CITY PLANNING COMMISSION
1231 "I" STREET, SUITE 200, SACRAMENTO, CA 95814

- B. Rezone 6.8± partially developed acres from Multi-Family Residential (R-4) to Office Business-Review (OB-R) zone;
- C. Plan Review to convert the existing Bishop Monogue School into offices and to construct a new two story, 38,300 square foot office building on 6.8 developed acres; and,
- D. Lot Line Adjustment to merge two existing lots into one lot.

APPLC. NO. P91-034

BISHOP MONOGUE CONVERSION TO OFFICE

EXHIBIT A
SITE PLAN

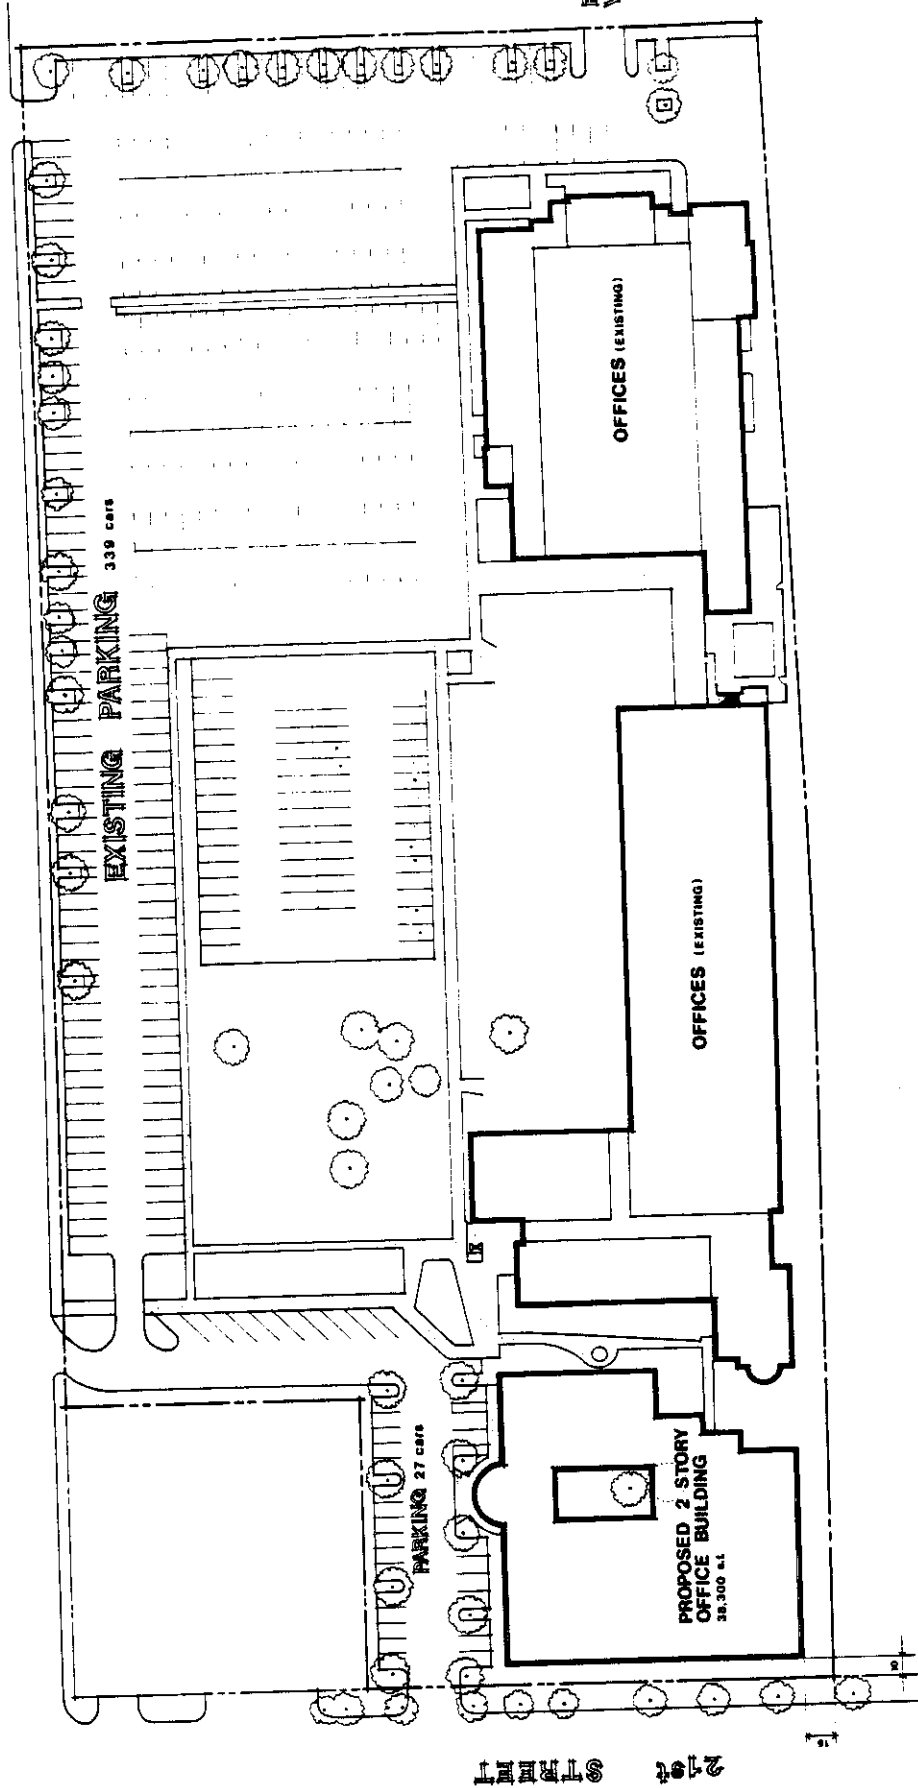
Parking- The applicant proposes a total of 366 parking spaces for the facility. This number is much more than is required and needed for the 260 employees and visitors who will be utilizing the site. The large number of spaces also contradicts direction given by the City Council.

The City Council has adopted interim parking regulations that are in effect at this time. Under the interim regulations, the maximum allowed parking for the project is 251 spaces (one space per every 400 square feet of office). The Council's interim parking regulations were adopted in an effort to reduce traffic congestion and air pollution. Currently, there are 282 existing spaces on the site with another 27 spaces proposed adjacent to 21st Street. Approximately 57 more parking spaces are proposed upon an existing tennis court. In addition, the property has been utilized as a parking facility for nearby office workers. This is an illegal use which requires an approved Special Permit to bring it into compliance. At this time, the granting of a Special Permit would be contrary to the City Council's adopted interim parking regulations. Since the parking spaces have existed prior to adoption of the interim parking regulations, staff has no objection provided the parking spaces are used by the converted and new offices. The existing tennis court should be retained as a recreational

facility for the office users. Other parking regulations need to be followed such as those pertaining to tree shading, surfacing, parking space dimensions, etc. Meeting these regulations may cause a loss in the overall number of parking spaces.

The proposed project was reviewed by City Engineering, Traffic Engineering, Community Services and Building Divisions. Their comments are reflected within the conditions of approval listed below. It should be noted that the City Transportation Division has recommended changes in the driveway access design to improve traffic circulation and safety. The driveway on 21st Street should be an entrance only; the driveway on Broadway closest to 21st Street should be exit only; another driveway for entrance and exit should be located between the two proposed driveways.

- 2. The existing parking lot shall conform to City standard for minimum dimensions (18 foot length and 8 foot width) with 26 feet of maneuvering;
- 3. The applicant shall install a six foot high decorative solid masonry wall along the southerly property line. The decorative wall plans shall be reviewed and approved by the Planning Director prior to issuance of any building permit;

- 6. All driveways shall be perpendicular to the street;

7. The driveway on 21st Street shall be an entrance only driveway;
8. The driveway on Broadway closest to 21st Street shall be exit only and be 10 feet from the property line;
9. The applicant shall construct another driveway for the entrance and exit on Broadway between the two proposed driveways;
10. The applicant shall redesign parking lot to break up the long straight aisle adjacent to Broadway;

EXHIBIT B-1
ELEVATION PROPOSED BLDG

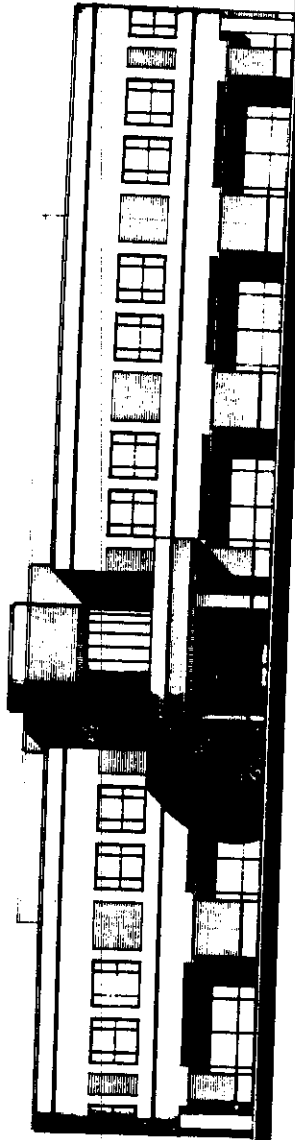
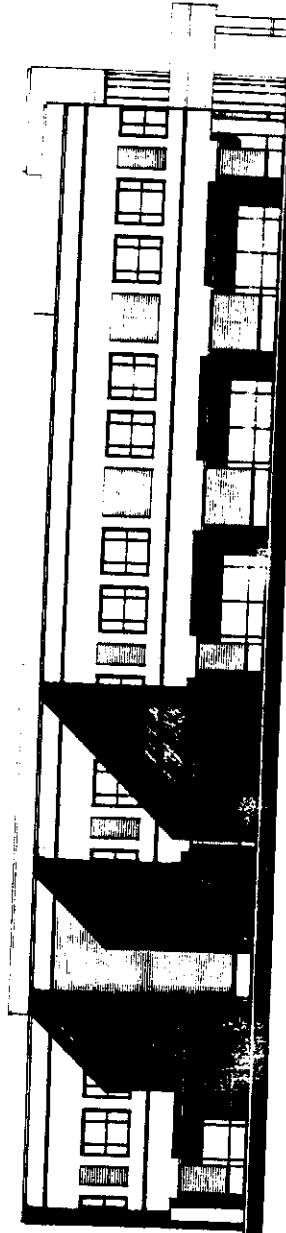
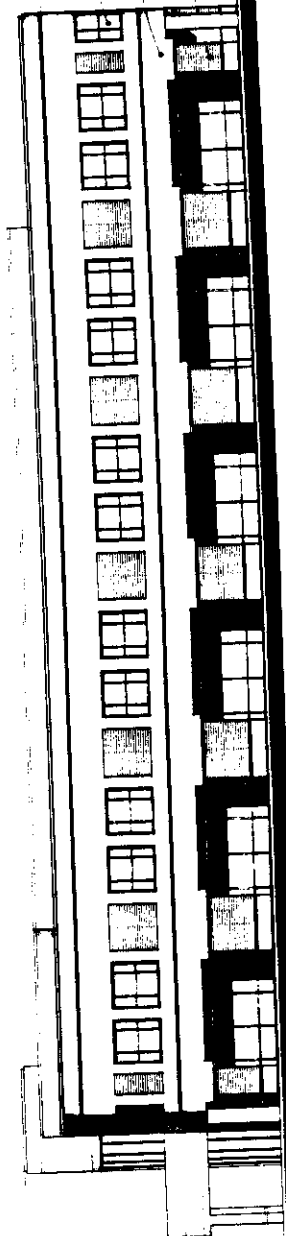
The proposed Bishop Manogue office project is not "pedestrian-friendly". It proposes a long stretch of parking lot adjacent to Broadway. The project seems to include little or no new landscaping. From what we can tell, the new building will be a tilt-up concrete building with some brick tile veneer and aluminum windows with tinted glass. Another tilt-up office building and parking lot is not likely to contribute to the enhancement of Broadway as a retail commercial/ entertainment corridor.
